MARKED UP PAGES FOR PROPOSED CHANGES TO APPENDIX A TECHNICAL SPECIFICATIONS OF FACILITY OPERATING LICENSES NPF-72 AND NPF-77

BRAIDWOOD STATION UNITS 1 & 2 REVISED PAGES:

FIGURE 3.4-2a
REACTOR COOLANT SYSTEM HEATUP LIMITATIONS
APPLICABLE UP TO 32 EFPY (UNIT 1)

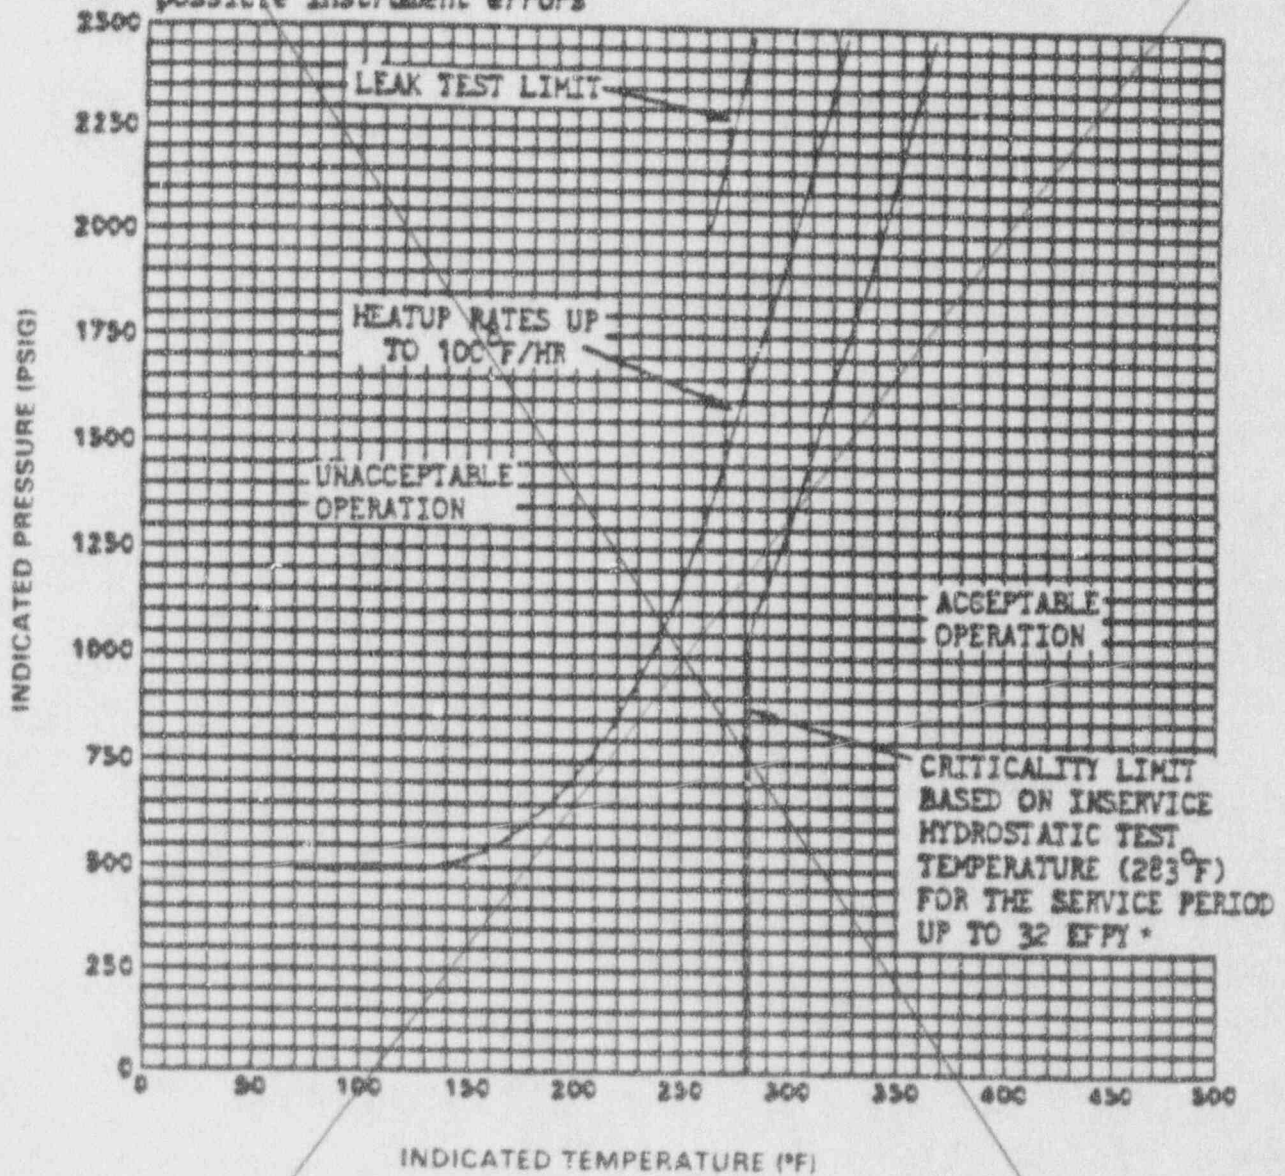
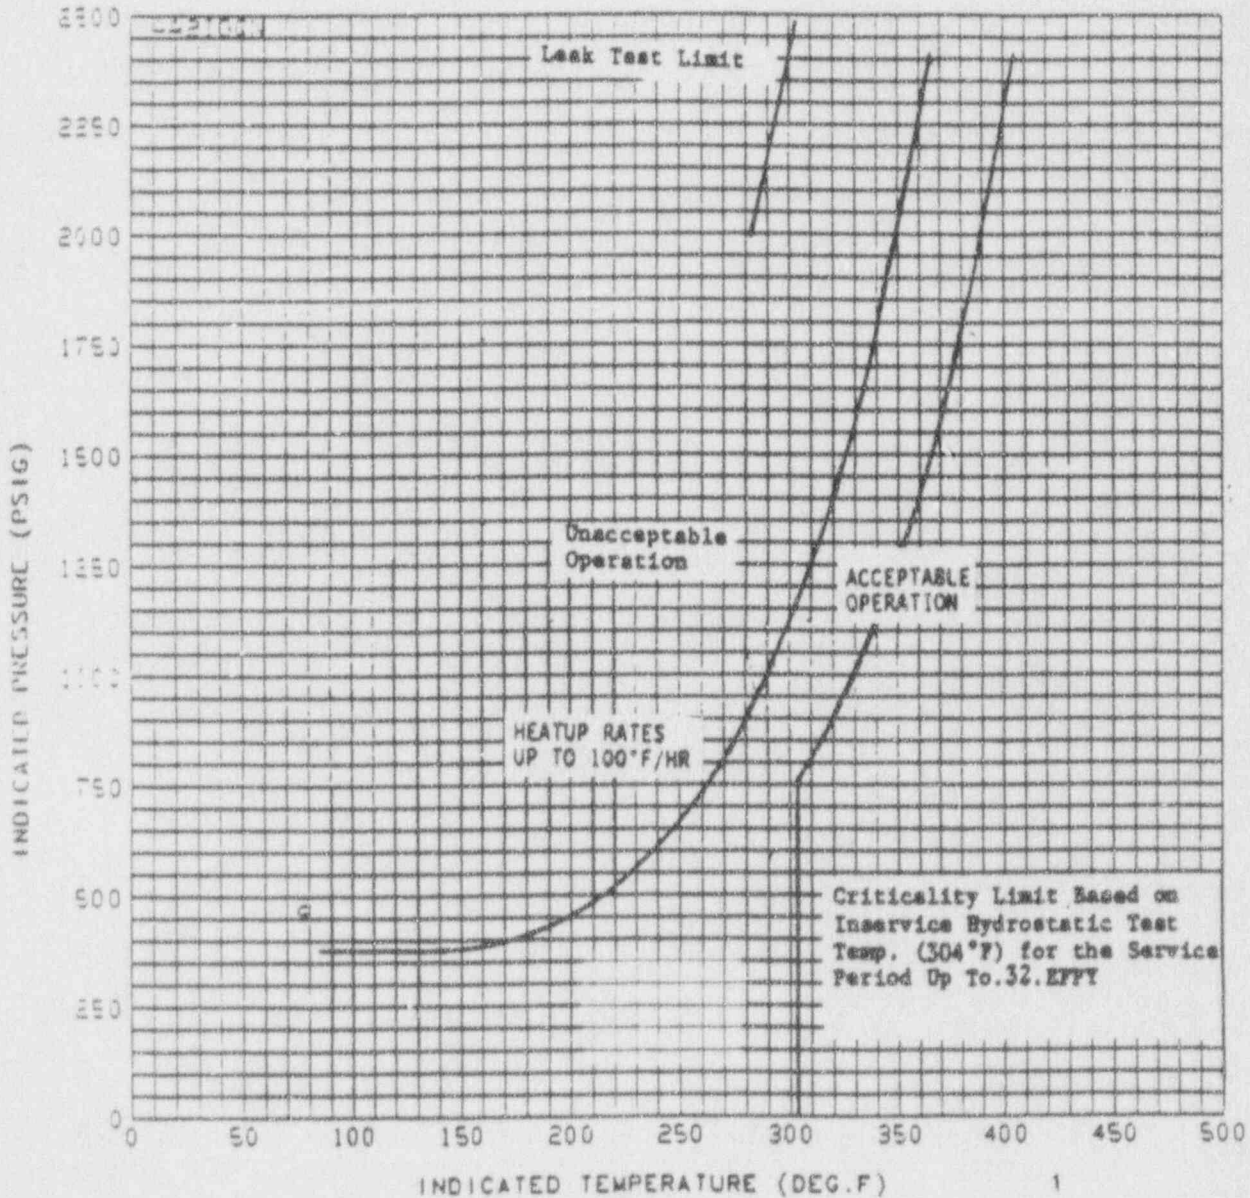
REPLACE THIS PAGE WITH ATTACHED PAGE

*applicability date has been reduced per Regulatory Guide 1.99 Revision 2 to 4.5 EFPY. The calculation to determine applicability utilized actual copper content of 0.05 wt%.

These curves are applicable for heatup rates up to 100°F/hr for the service period up to 32 EFPY and contain margins of 10°F and 60 psig for possible instrument errors.

FIGURE 3.4-3a

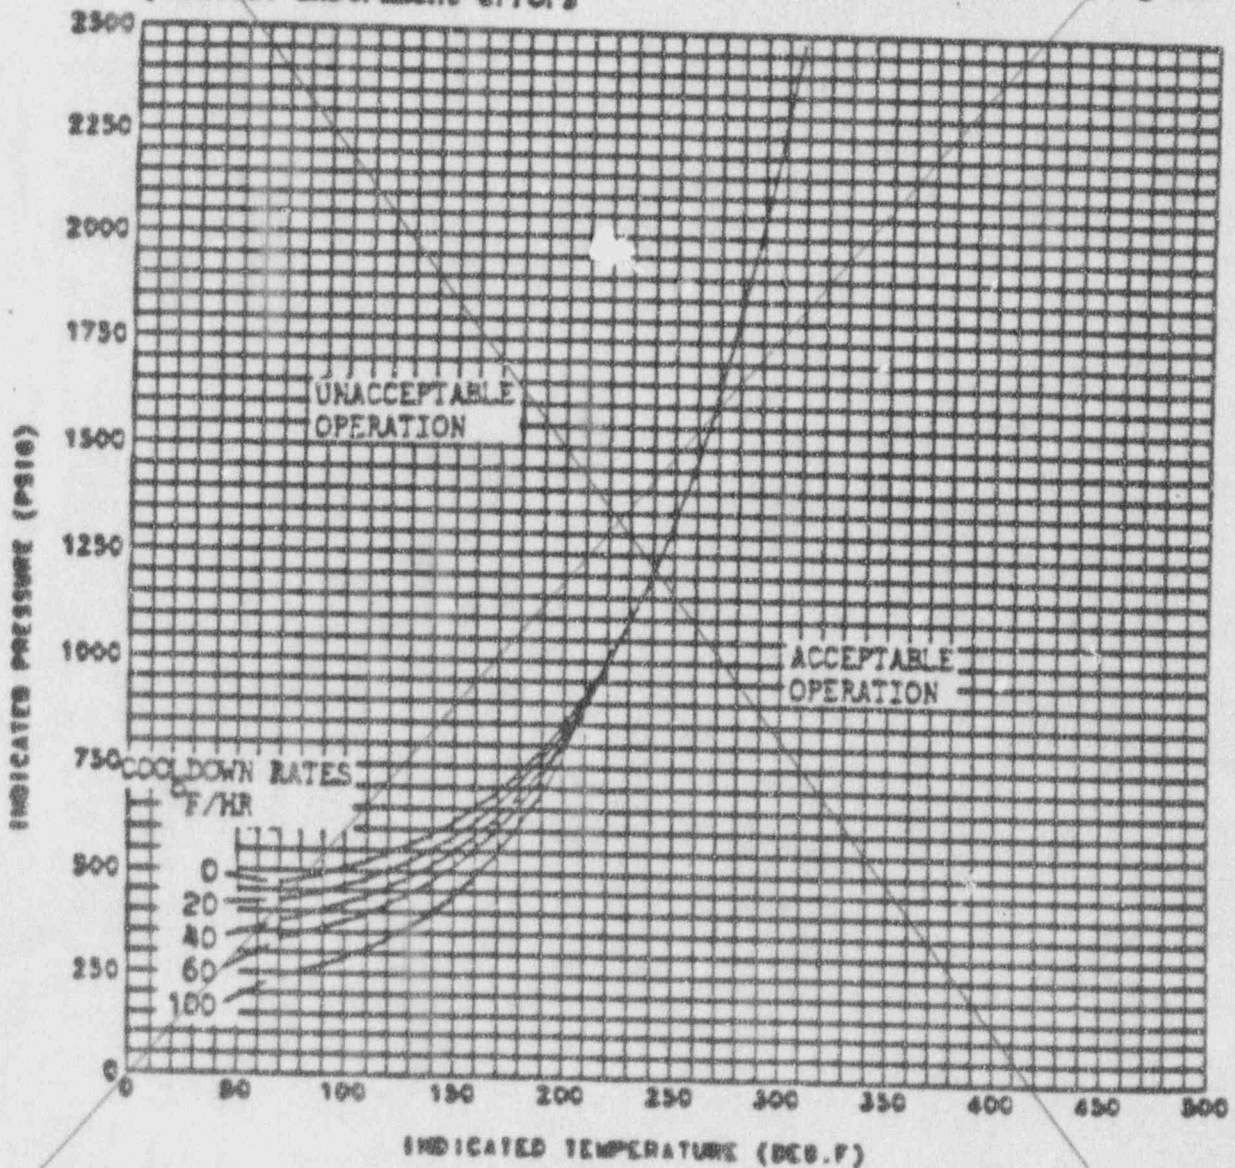
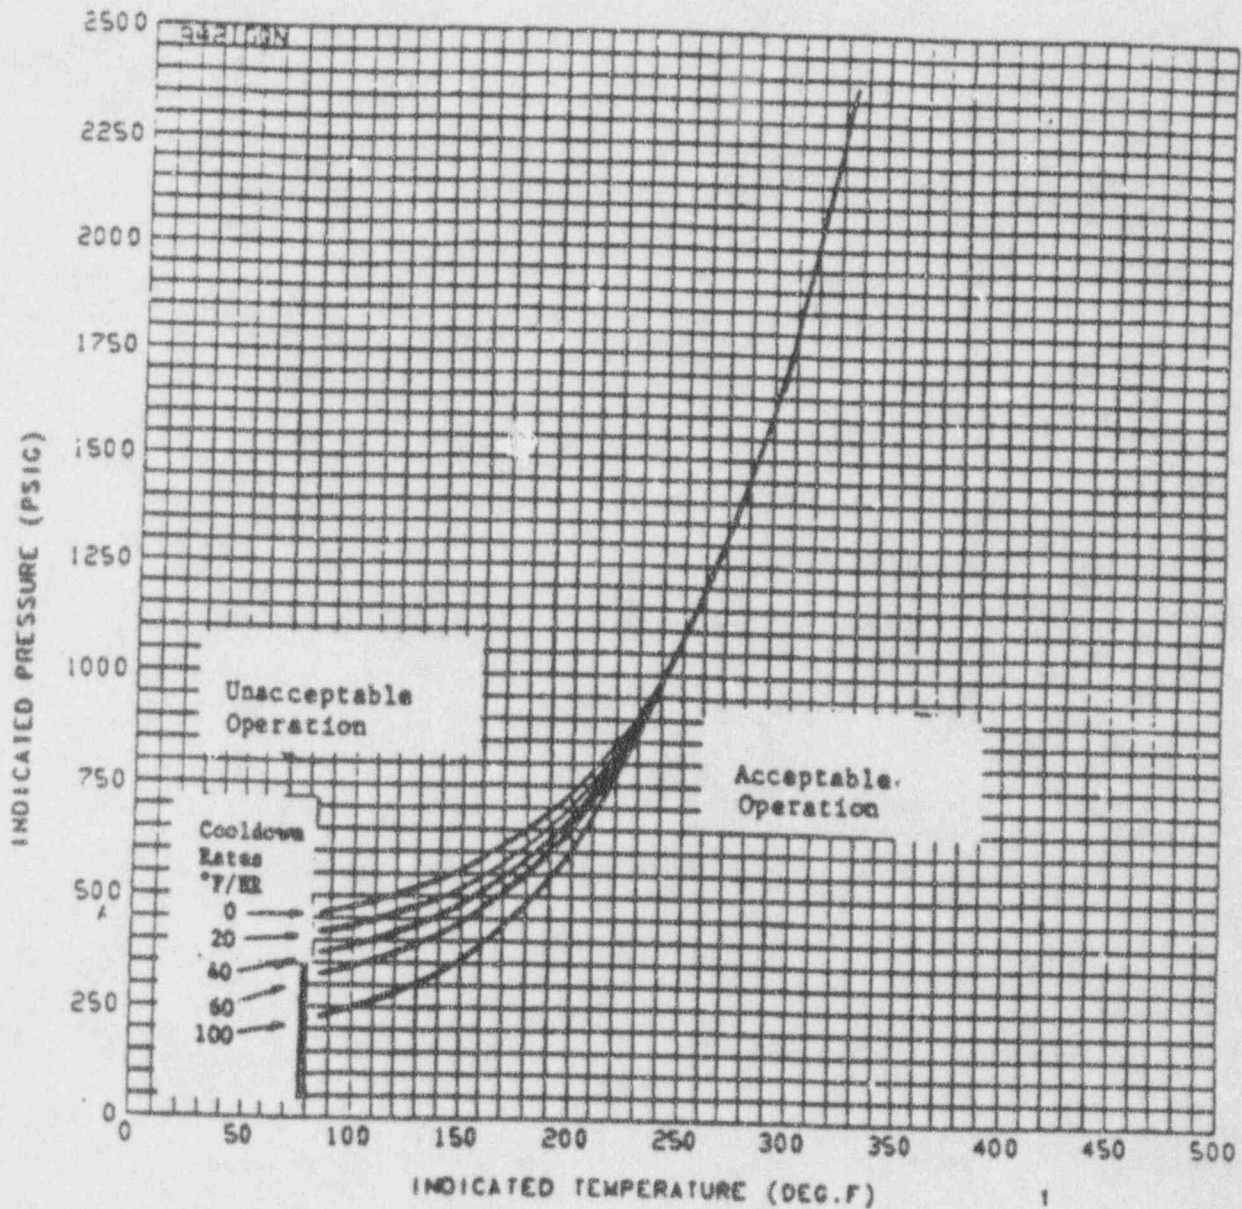
REPLACE THIS PAGE WITH ATTACHED PAGE.

*applicability has been reduced per Regulatory Guide 1.99 Revision 2 to 12 EFY. The calculation to determine applicability utilized actual copper content of 0.05 wt%.

These curves are applicable for cooldown rates up to 100°F/hr for the service period up to 32 EFPY and contain margins of 10°F and 60 psig for possible instrument errors.

FIGURE 3.4-4 a

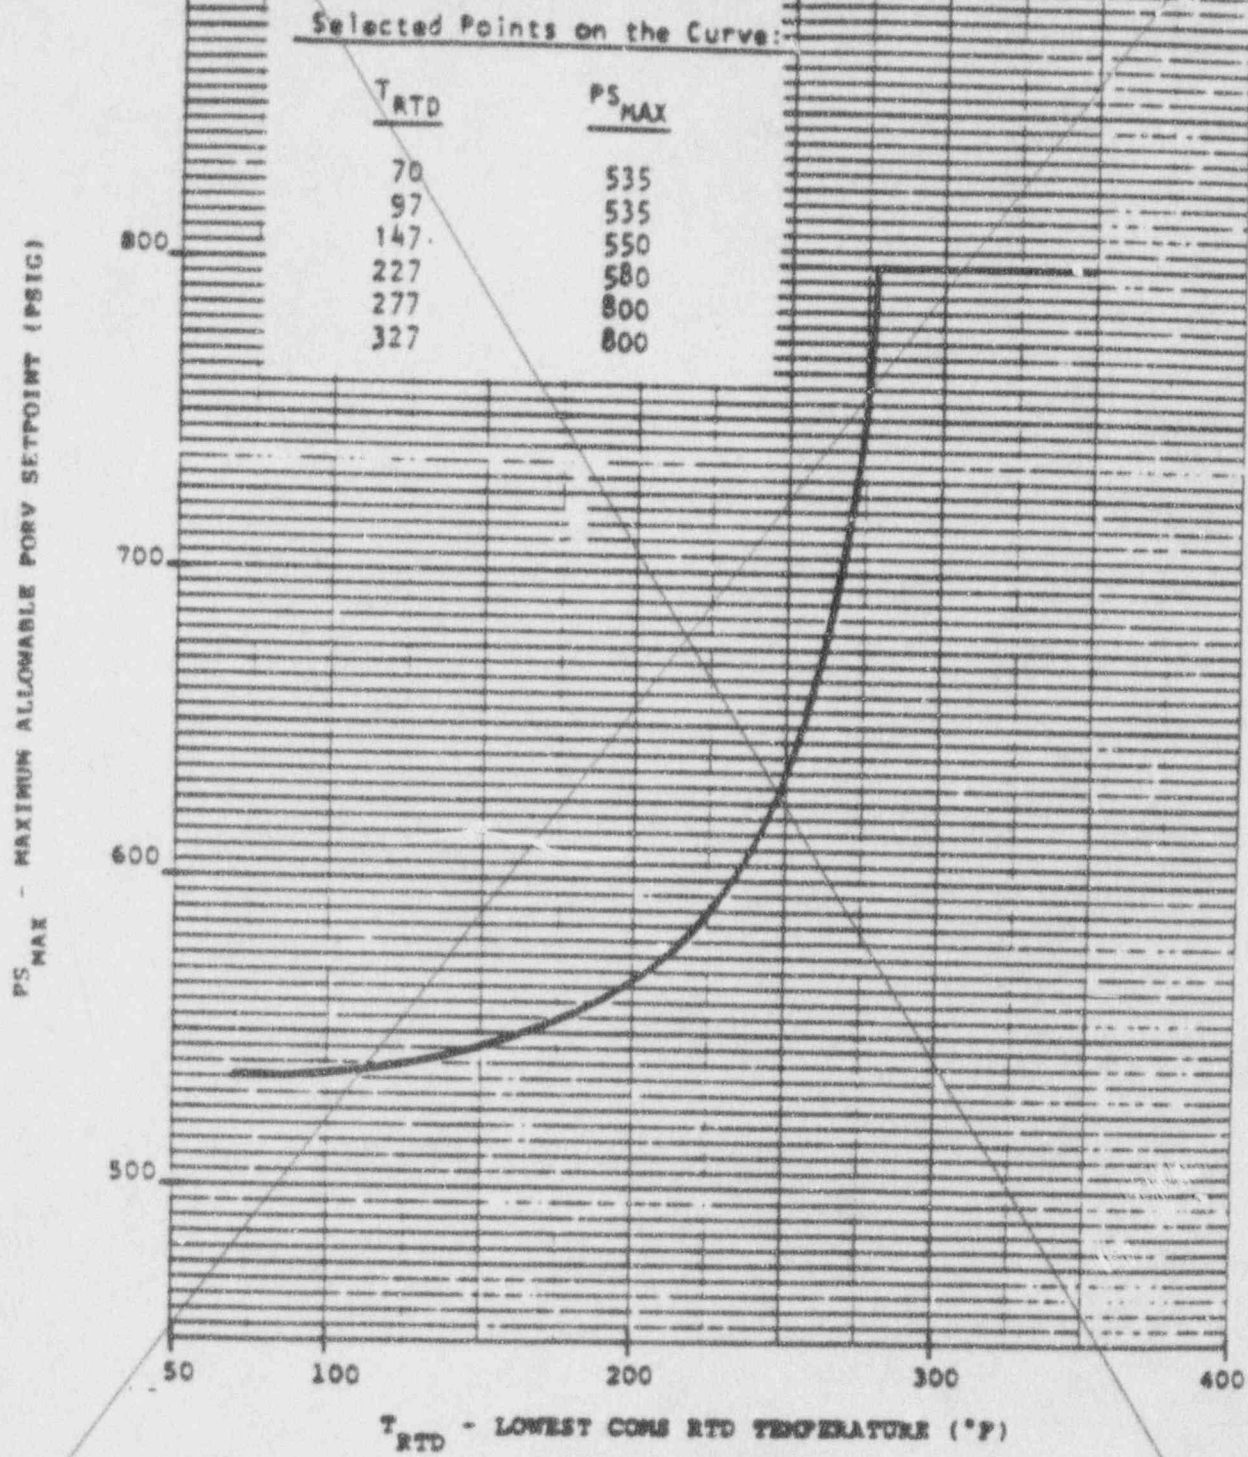
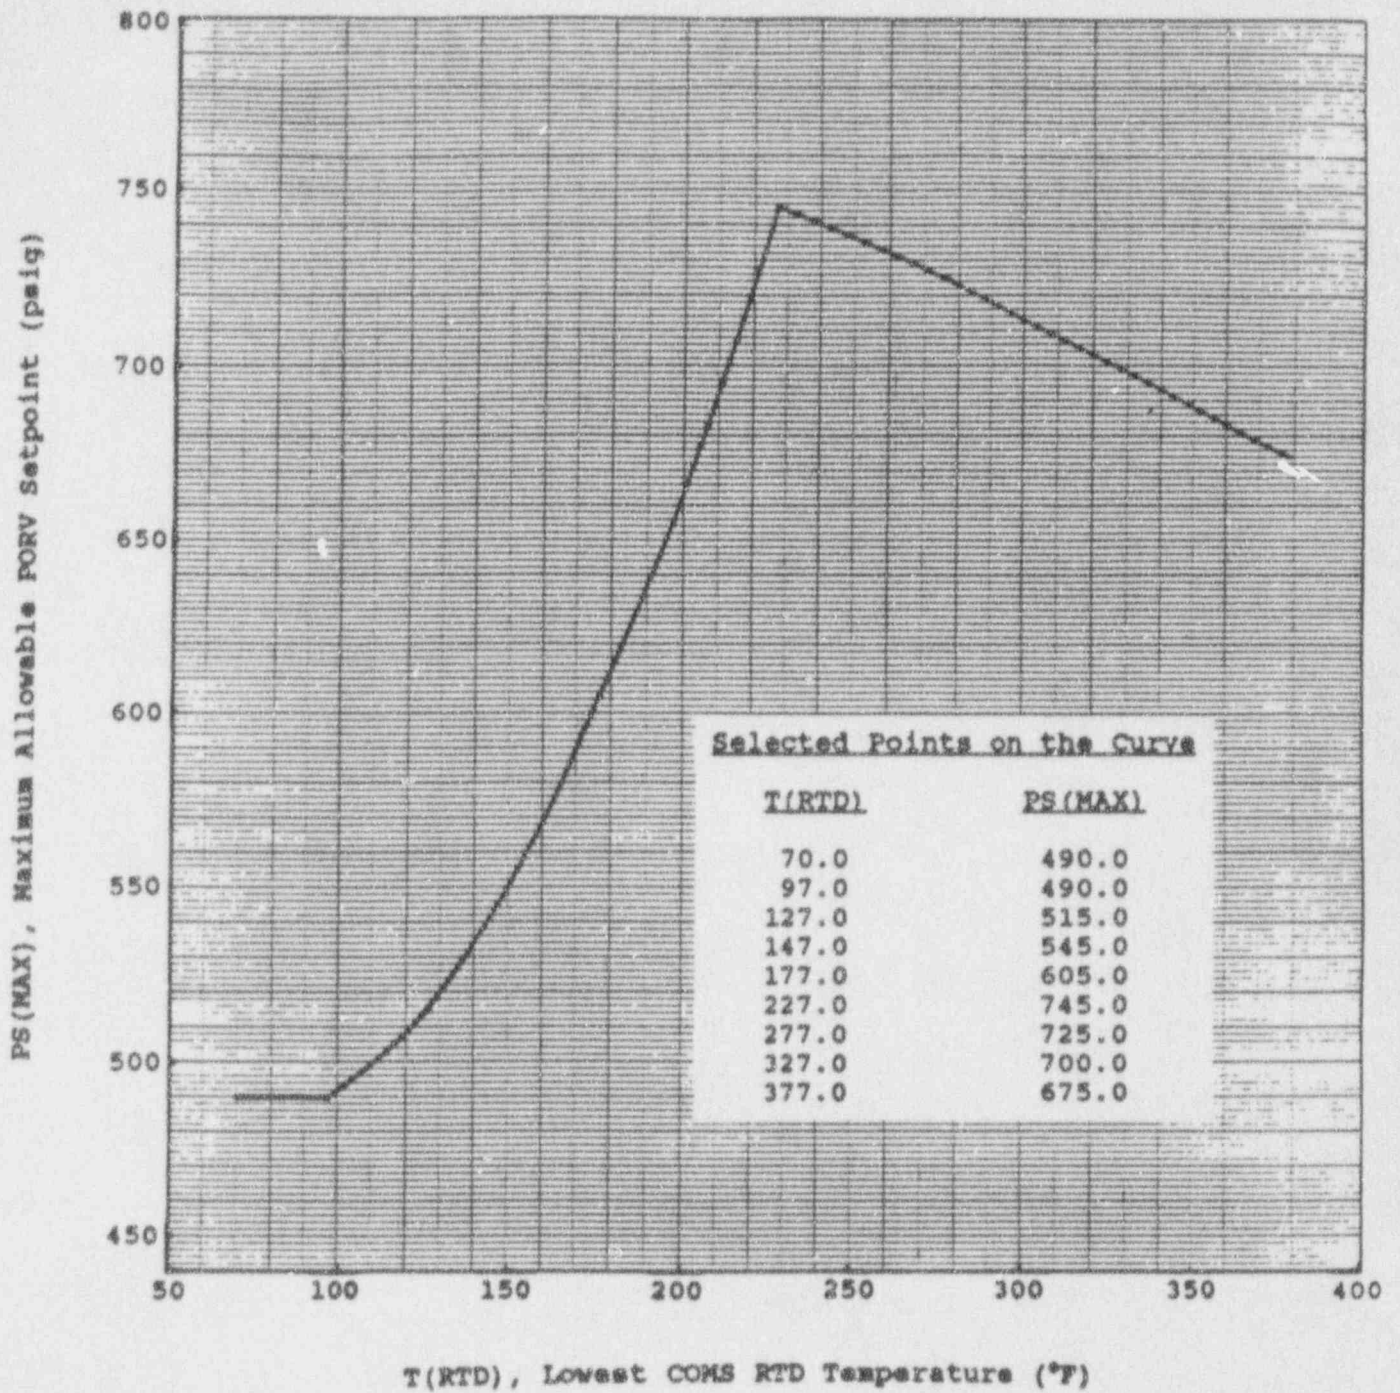
REPLACE THIS PAGE
WITH ATTACHED
PAGE

*applicability has been reduced per Regulatory Guide 1.99 Revision 2 to 4.5 EFPY.
The calculation to determine applicability utilized actual copper content of 0.05 wt%.
